This application was reported to the Planning Committee meeting on 6th August 2025, with a recommendation for refusal. The report below sets out the officers' reasons. However, the committee resolved to overturn this recommendation and granted the application, subject to conditions. The conditions are as follows:

No:	25/0261	Ward:	Rogerstone West
Type:	Full		
Expiry Date:	29th May 2025		
Applicant:	Coombs		
Site:	4 Pontymason Close Rogerstone Newport NP10 9HG		
Proposal:	RESUBMISSION OF RETROSPECTIVE APPLICATION TO RETAIN TERRACED PATIO AREAS		
Recommendation:	REFUSED

Garden prior to works, photos on Pinkmove:

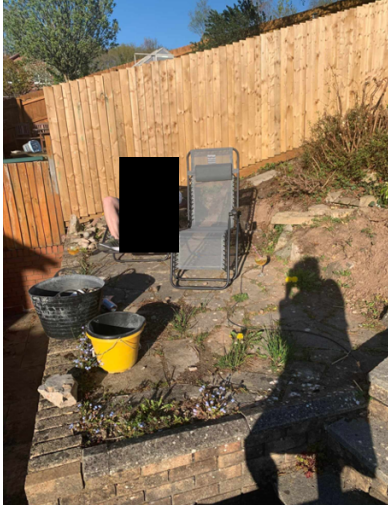
7.1.2 When assessing the development, it should be noted that part of this development is retrospective, and the existing ground levels prior to works cannot be fully confirmed on site. Confirmation from the applicant has been provided through plans and images of the garden prior to works which can be seen below. In terms of the first plateau, part of this area is existing. The second and third plateau, are proposed retrospective development.

7.1.3 Prior to works on tier A, the space closest to no.3 could have been used as a vegetable patch area with gravel from the videos/photos provided of the house prior to being bought. The area closest to no.5. appears to have sustained some form of small patio area as

submitted from the applicant's picture below. The rest of the garden appeared to continue to gradually slope to the top of the garden where a shed is situated.

Prior to works:

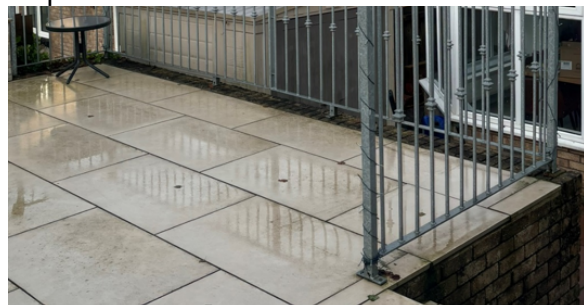
- 7.2.1 Tier A is the closest tier to the dwellinghouse. It is noted that the retaining wall on tier A is pre-existing and this retaining wall does not change in height as part of this submission. The applicant has added a 1m balustrade on top of the existing retaining wall. This is deemed acceptable for safety measures. When addressing if the tier has been built up, the image prior to works demonstrates there was a slight lip on the top of the wall as shown below. The current image of the plateau demonstrates the patio slabs now meet the top of the wall. The laying of patio slabs here increases the height marginally and is acceptable. The applicant demonstrates that part of the tier to the rear has been altered under 300mm and the area closest to number 5 has been reduced over 300mm. Whilst the land level changes here are not substantial, it is noted that the works undertaken have created a more useable levelled platform to what was pre-existing, and the impacts are further discussed below.
